## Evaluation of proposed move for Water Right No. 3762

Proposed: Move water right no. 3762 to a new well location, 2609 ft to the southeast.

Data Set: C:\Users\trevora\Documents\2022_moves\3762\3762 Current.aqt
Date: 06/30/22   Time: 14:15:30

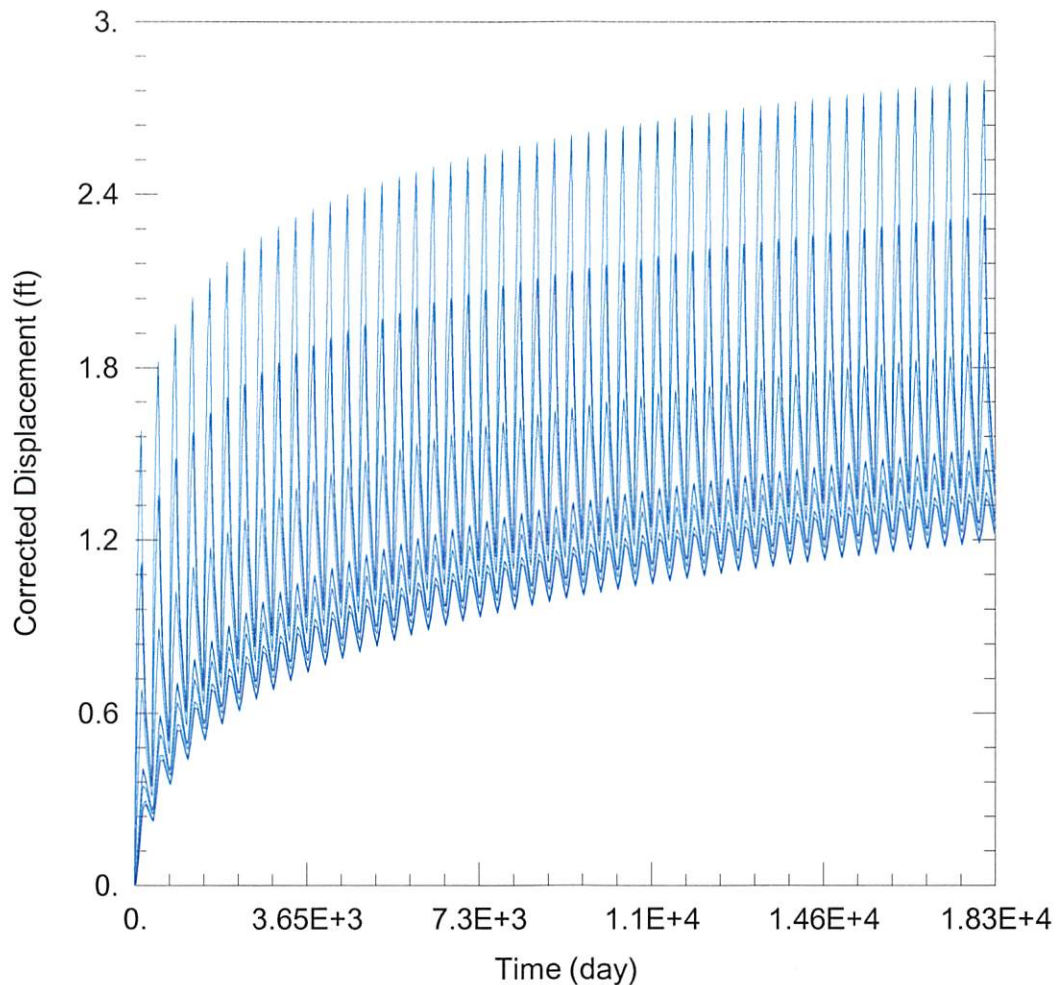
3148:	Drawdown from current location = 1.52 ft
	Drawdown from proposed location = 6.09 ft
	Net drawdown = **4.6 ft**
20248:	Drawdown from current location = 1.51 ft
	Drawdown from proposed location = 5.68 ft
	Net drawdown = **4.2 ft**

554: Drawdown from current location = 1.45 ft

Drawdown from proposed location = 6.55 ft

Net drawdown = **5.1 ft**

11645: Drawdown from current location = 1.37 ft

Drawdown from proposed location = 7.14 ft

Net drawdown = **5.8 ft**

6846: Drawdown from current location = 1.34 ft

Drawdown from proposed location = 6.11 ft

Net drawdown = **4.8 ft**

Domestic 7-31-32: Drawdown from current location = 2.80 ft

Drawdown from proposed location = 6.05 ft

Net drawdown = **3.3 ft**

Domestic 8-31-32: Drawdown from current location = 2.32 ft

Drawdown from proposed location = 5.41 ft

Net drawdown = **3.1 ft**

Domestic 18-31-32: Drawdown from current location = 1.85 ft

Drawdown from proposed location = 8.70 ft

Net drawdown = **6.8 ft**

Net drawdown exceeds the drawdown allowance of 3.5 ft for all irrigation wells within 1 mile of the proposed location, and the domestic well in section 18-31-32. Critical well analysis was performed on those wells.
